Technical Service Information

ACURA 4 SPEED HYDRAULIC NO UPSHIFT

Figure 1

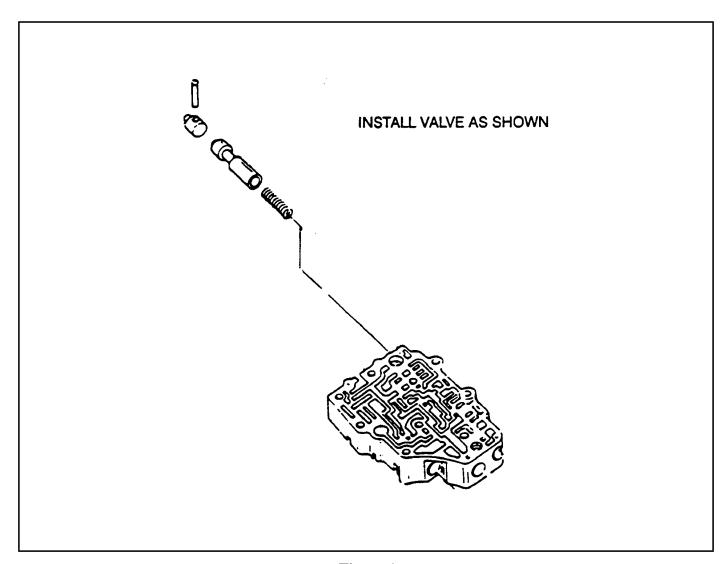
COMPLAINT: No upshifts (T.V. and governor pressure ok).

CAUSE: Mis-assembly of the CPV valve and spring.

CORRECTION: Remove and install correctly.
